TEMPORARY DRAINAGE PROPOSAL

APPLICATION SITE OF THE PROPOSED
TEMPORARY SHOP AND SERVICES (SALES OF
HARDWARE ACCESSORIES) FOR A PERIOD OF 3
YEARS AT LOTS 772 (PART) AND 787 (PART) IN
D.D. 115, CASTLE PEAK ROAD-YUEN LONG
SECTION, YUEN LONG

APPLICATION NO. A/YL-NSW/331

Response to Comments on draft Temporary Drainage Proposal

Appendix C - Drainage Plan

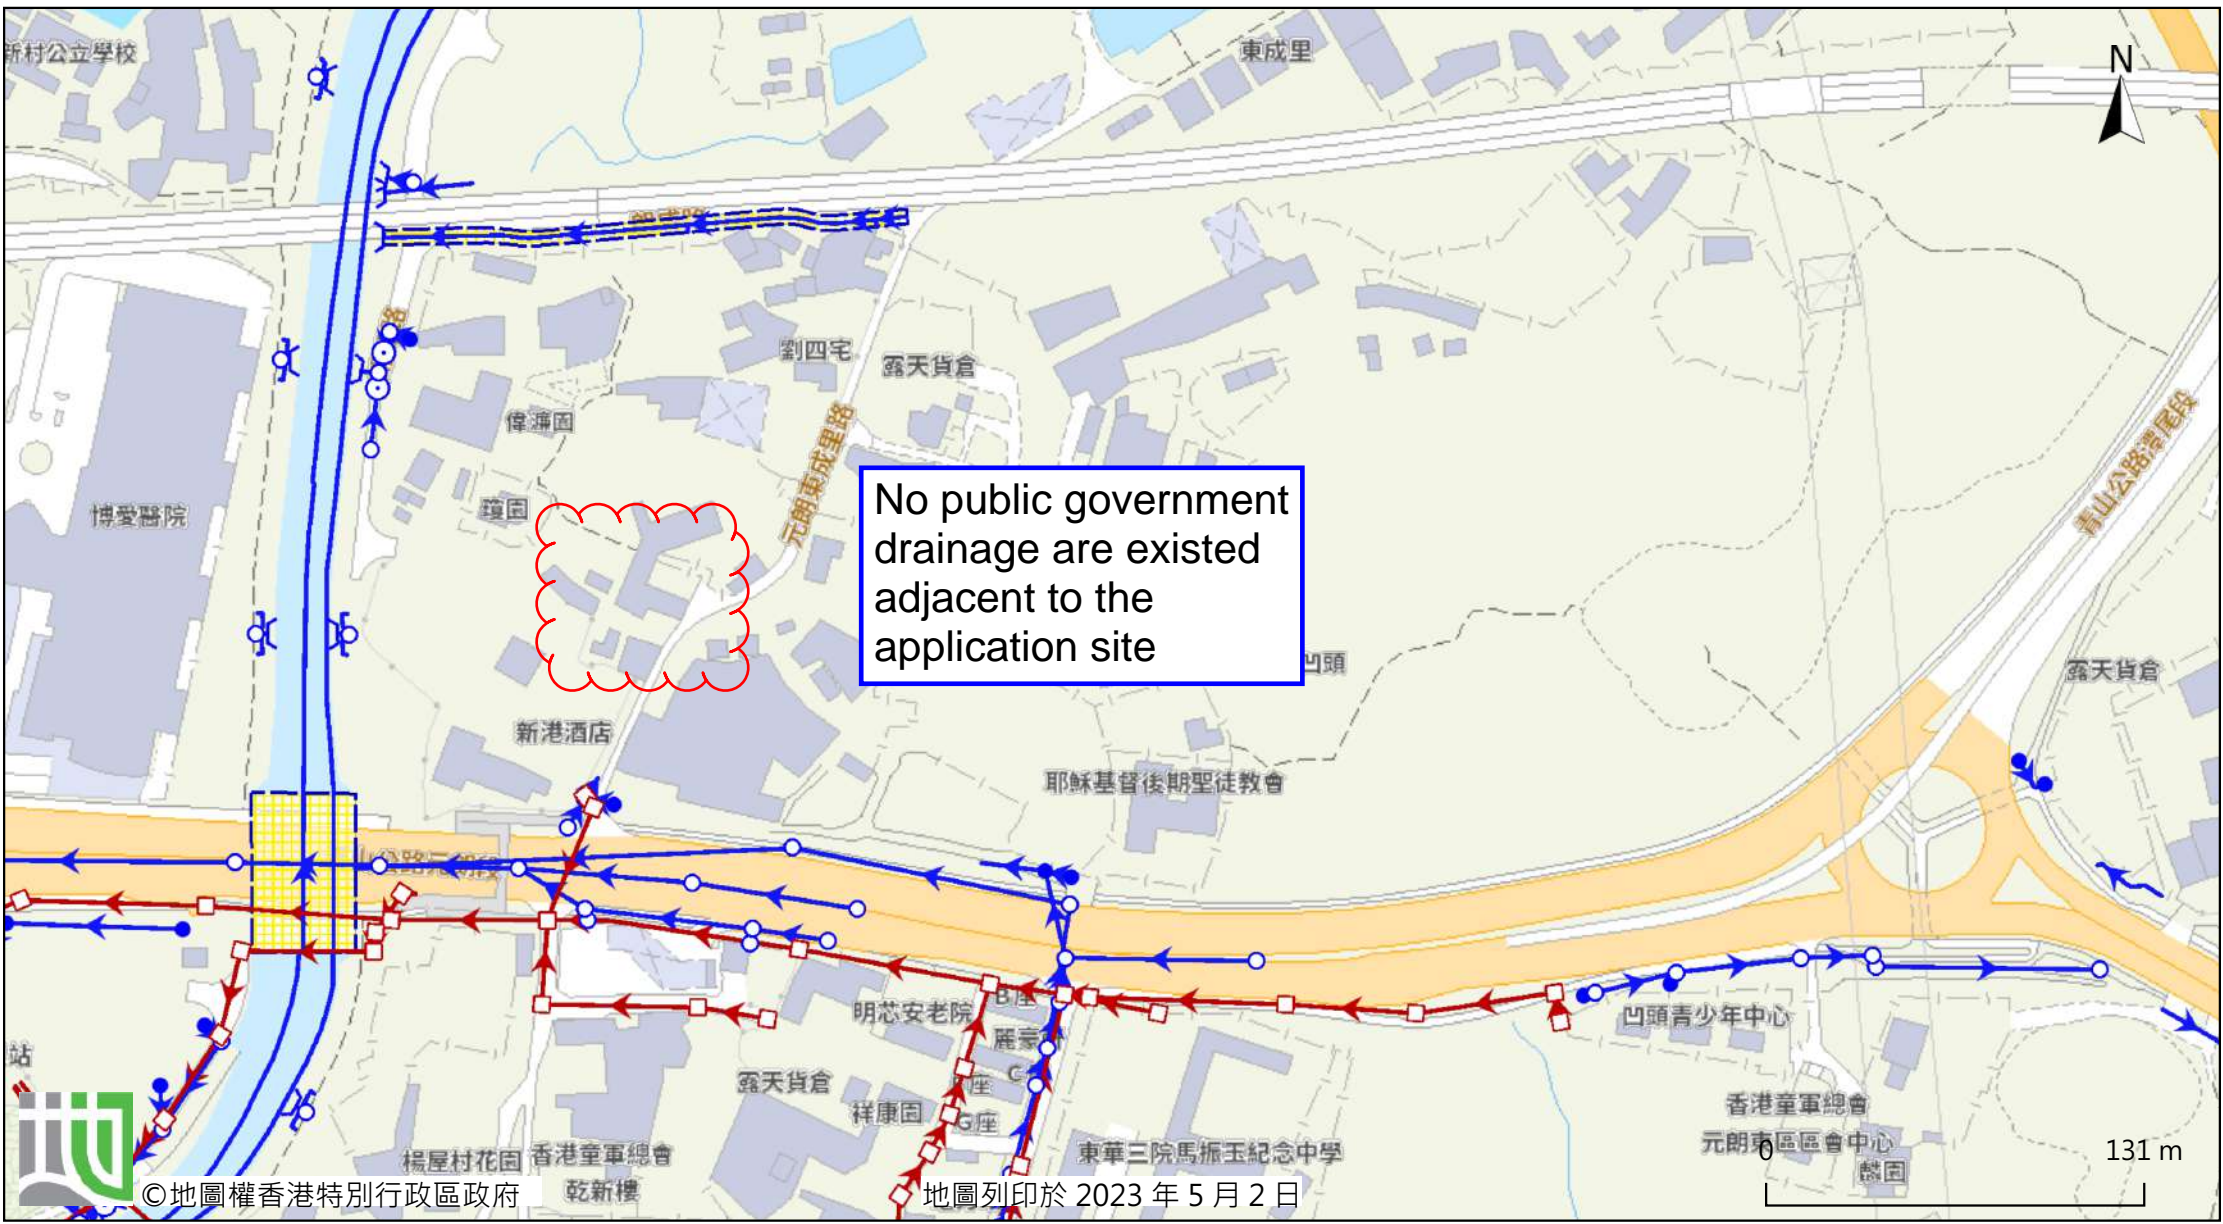
No.	Comments	Response
1.	The submitted drainage proposal does not include most of the essential information such as u- channels gradient, relevant hydraulic calculations, provision/ cover and invert levels of catchpits, cross sections of the site and adjacent areas, u-channel/catchpit standard details, etc.	Noted. Please refer to the captioned Drainage report. The assessment reviews the drainage pipe have the sufficient capacity to cater for the drainage flow from the Application Site.
2.	The applicant is required to submit a revised drainage proposal for vetting. In general, peripheral surface channels shall be provided along the site boundary to collect the surface runoff accrued on the application site and to intercept the overland flow from the adjacent lands.	Noted with thanks. The revised drainage proposal are therewith submitted for your approval.
